R03HC

Davenport Seat Belt Anchorage

MODELS AFFECTED: 2004 Blue Bird All American Rear Engines (A3RE) with Seat Belts

RECALL CAMPAIGN R03HC

Figure 1

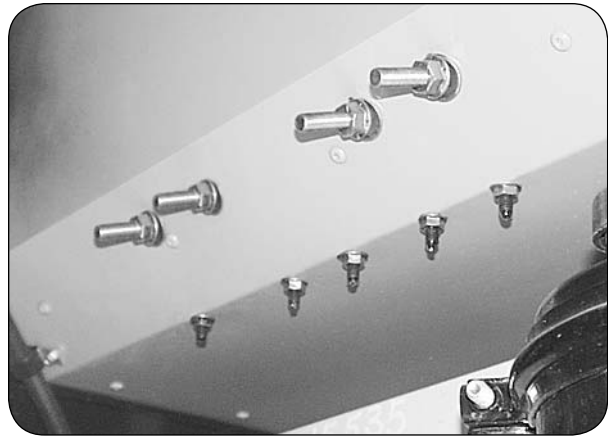
- 1** Park the bus on a level surface and apply the parking brake. Remove the key and chock the wheels. Disconnect the battery cables.
- 2** Open the engine compartment, allow the engine ample time to cool to ambient temperature.
- 3** Inspect the seat belt anchorage bolts protruding from the rear davenport wall. If the fasteners appear as shown in Figures 1 or 2 **STOP**. These installations are acceptable.

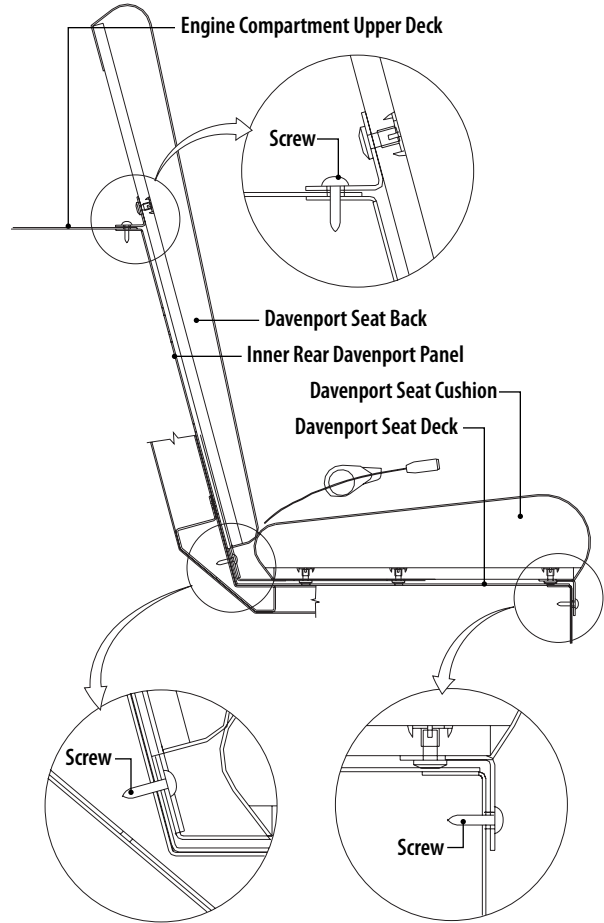
6 Using the hole pattern diagram that coincides with your seat size, drill 15/32 inch (.468) diameter holes through the rear davenport panel 7/8 inch (.88) above davenport seat deck. Maintain the drill at a 90 degree angle to the rear davenport seat panel. See "Hole Pattern Diagram" on page 3.

Steps Four Through Six

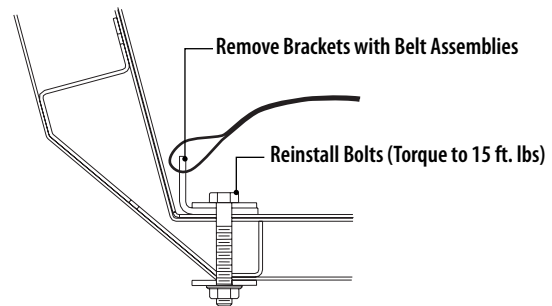
4 Remove screws that secure both davenport seat backs to the rear engine compartment upper deck. Lift and remove the seat backs.

5 Compress the rear of the davenport seat cushion and remove the screws that secure the seat cushions to the inner rear davenport panel.

6 Remove screws that secure the front edge of the davenport seat cushions. Lift and remove the seat cushions.

Steps Seven & Eight

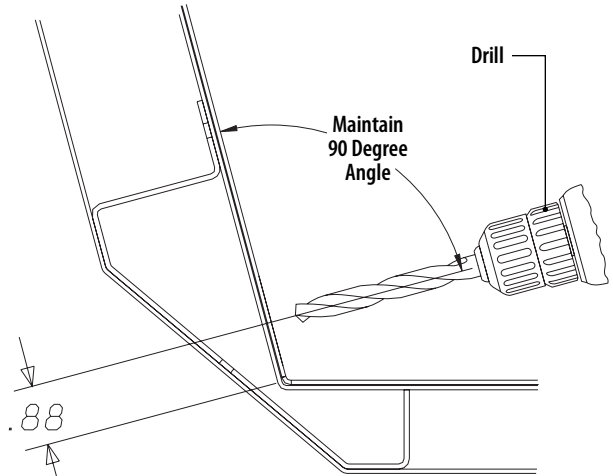
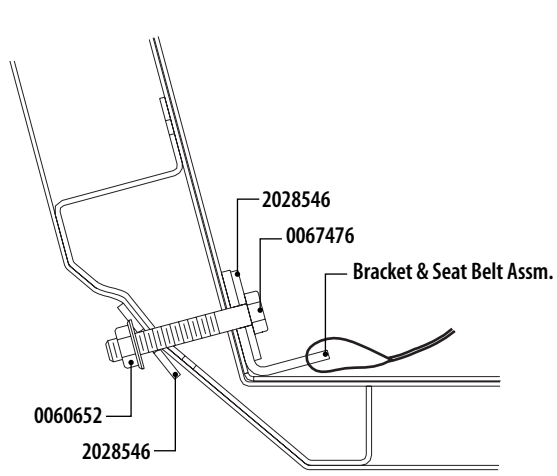
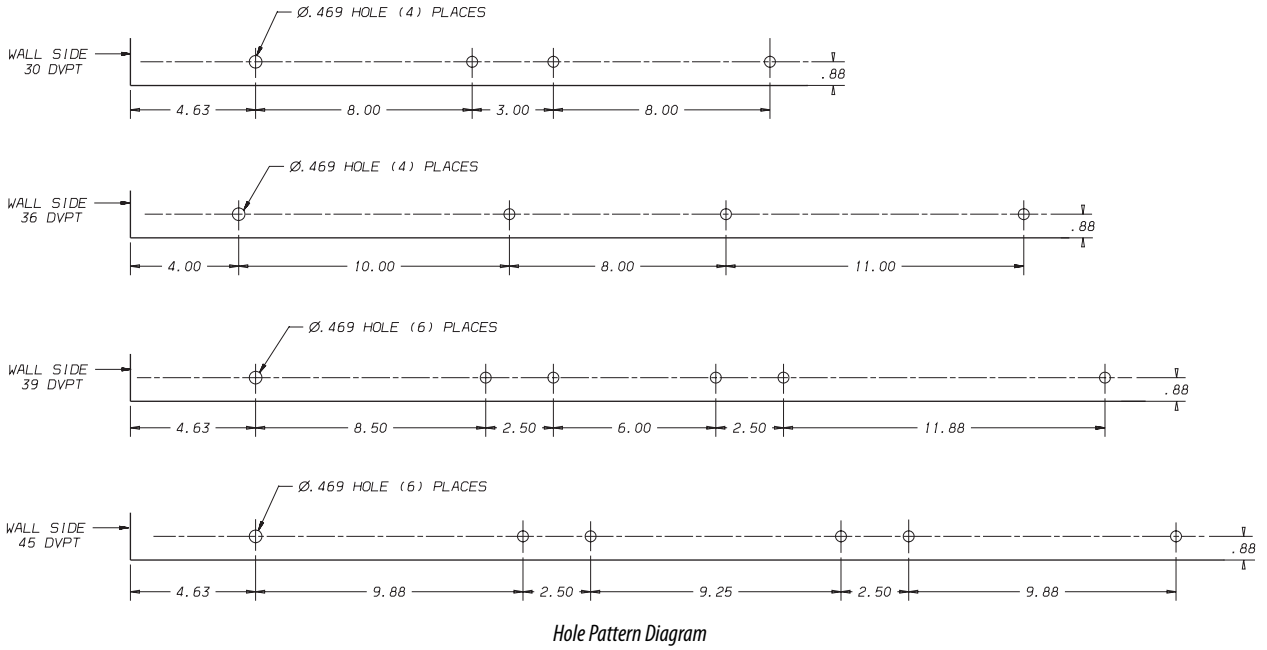
7 Inspect the bracket and seat belt assemblies, if damage to the bracket exist, please contact Bill Coleman at Blue Bird Body Company; Phone 478.822.2242.

8 Install bracket with seat belt in new position as shown in "Seat Belt Bracket Installation" on page 3. Install new 7/16 - 20 x 2.25 inch bolt (BB #0067476), two flat washers (BB #2028546) and flanged nut (BB #0060652). Bolts must be torqued to 30-33 ft. lbs.
